# UNITED STATES PATENT AND TRADEMARK OFFICE

APPLICATION NO.	FILING DATE	FIRST NAMED INVENTOR	ATTORNEY DOCKET NO.	CONFIRMATION NO.
10/798,422	03/12/2004	Seiji Horino	Q79112	6553
23373 7590 01/25/2007 SUGHRUE MION, PLLC 2100 PENNSYLVANIA AVENUE, N.W. SUITE 800 WASHINGTON, DC 20037			EXAMINER ROJAS, OMAR R	
			ART UNIT	PAPER NUMBER
			2874	
SHORTENED STATUTORY PERIOD OF RESPONSE		MAIL DATE	DELIVERY MODE	
3 MONTHS		01/25/2007	PAPER

**Office Action Summary**

## **DETAILED ACTION**

本発明の一実施例の斜視図

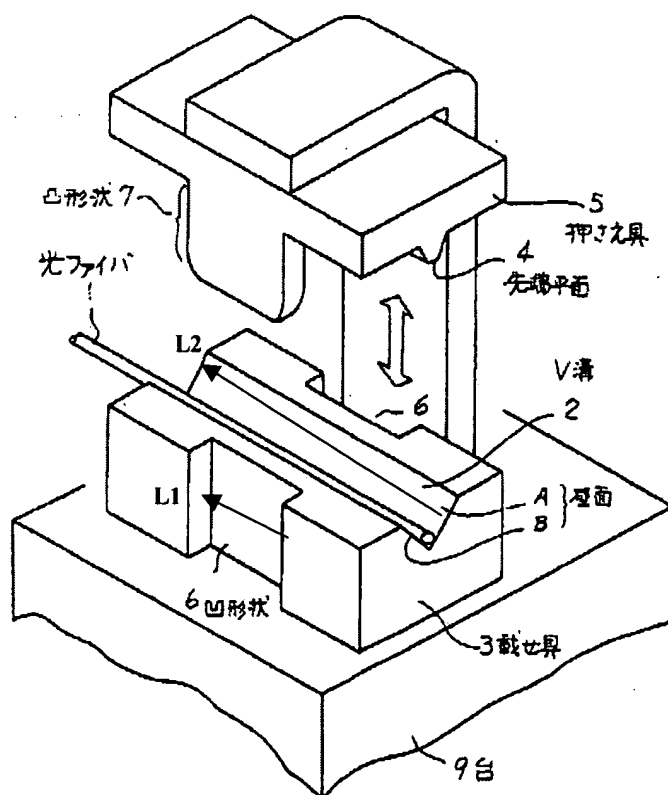
With respect to the Igarashi reference, applicant(s) are reminded that the grooves 2 and 6 shown by Igarashi also represent real, three-dimensional objects. Both grooves inherently have a length, a width, and a depth. For applicant's convenience, Figure 1 of Igarashi has been modified to show the length dimensions of the grooves 2 and 6. These length dimensions have been labeled as "L2" and "L1". The modified Figure 1 of Igarashi is show below.

As seen in the modified Fig. 1 of Igarashi, the length L1 of groove 6 extends in the same general direction as the length L2 of groove 2. Thus, the grooves 2 and 6 of Igarashi extend in the same direction and, therefore, also anticipate claim 1.

FIG. 14

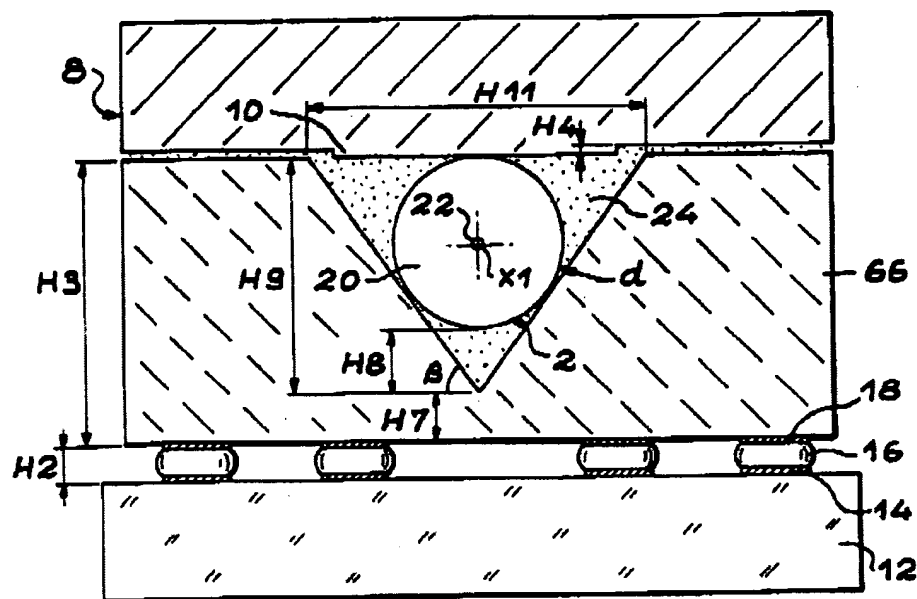
*In re* claim 1, Parat discloses in Figure 14, an optical fiber fixing system for fixing an optical fiber comprising:

a fixing body 66 comprising a first groove, formed in a top surface thereof, extending in a first direction to support the optical fiber 2 along its axial direction; and

a pressing body 8 comprising a protrusion 10, formed on a bottom surface thereof, and extending substantially perpendicularly to the direction of the first groove, wherein the bottom

surface of the pressing body 8 faces the top surface of the fixing body 66. Figure 14 of Parat is reproduced below.

*In re* claim 2, the bottom surface of the pressing body 8 and the top surface of the fixing body 66 are substantially planar.

*In re* claim 4, the cross section of the first groove is V-shaped as seen in Figure 14.

*In re* claim 29, the pressing body 8 is movable towards the fixing body 66 so that the optical fiber 2 is fixed therebetween by the protrusion 10 pressing the optical fiber 2 against the first groove (col. 11, lines 53-55).

Figure 13 of Sherrer is reproduced below.

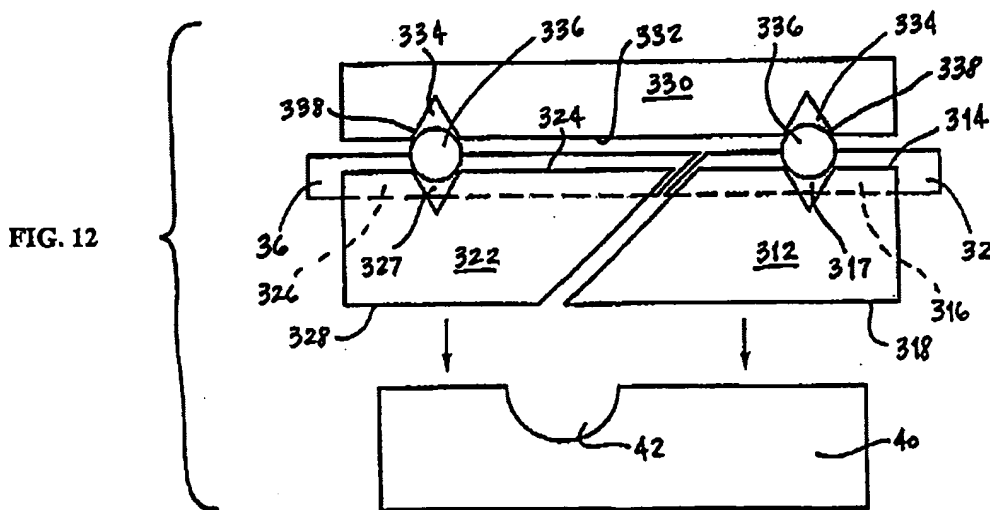
*In re* claim 1, Sherrer discloses in Figures 12-13, an optical fiber fixing system for fixing an optical fiber comprising:

a fixing body 322 comprising a first groove 326, formed in a top surface 324 thereof, extending in a first direction to support the optical fiber 36 along its axial direction; and

a pressing body 330 comprising a protrusion 336, formed on a bottom surface 332 thereof, and extending substantially perpendicularly to the direction of the first groove 326, wherein the bottom surface 332 of the pressing body faces the top surface 324 of the fixing body.

*In re* claim 2, the bottom surface 332 of the pressing body 330 and the top surface 324 of the fixing body 322 are substantially planar.

*In re* claim 3, when the optical fiber 36 is supported in the first groove 326, a ridgeline of the optical fiber 36 protrudes out of the first groove above the top surface 324 of the fixing body 322.

図 1

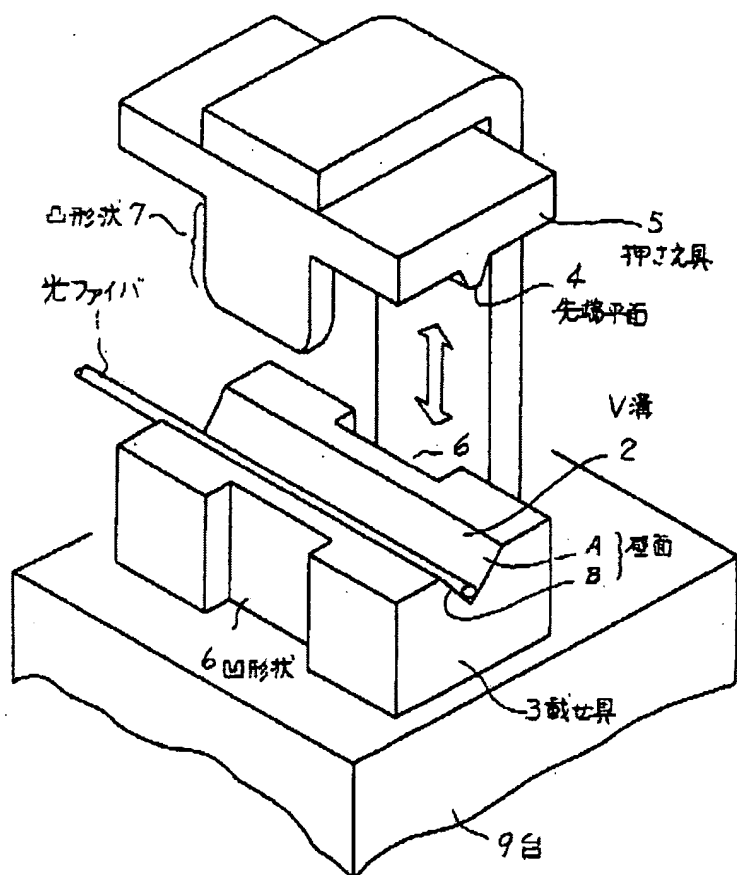
*In re* claim 32, Igarashi discloses an optical fiber fixing system (Figures 1 and 2) for fixing an optical fiber comprising:

a fixing body 3 comprising a first groove 6 formed in a first surface thereof, and a second groove 2 formed in a second surface thereof, both extending in a first direction to support the optical fiber 1 along its axial direction; and

a pressing body 5 comprising a planar clamp portion 7 facing the first surface of the fixing body 3, and a guide portion 4 facing the second surface of the fixing body 3 and comprising two sloped portions configured to interface with the second groove 2 to align the optical fiber therein. Figure 1 of Igarashi is reproduced below.

*In re* claim 34, the guide portion 4 further comprises a bottom surface arranged between the two sloped portions as seen in Figure 1.

*In re* claim 35, the fixing body 3 and pressing body 5 are arranged adjacently to fix the optical fiber 1 therebetween, the bottom surface of the guide portion 4 is located above the ridgeline of the optical fiber 1 supported in the second groove 2.
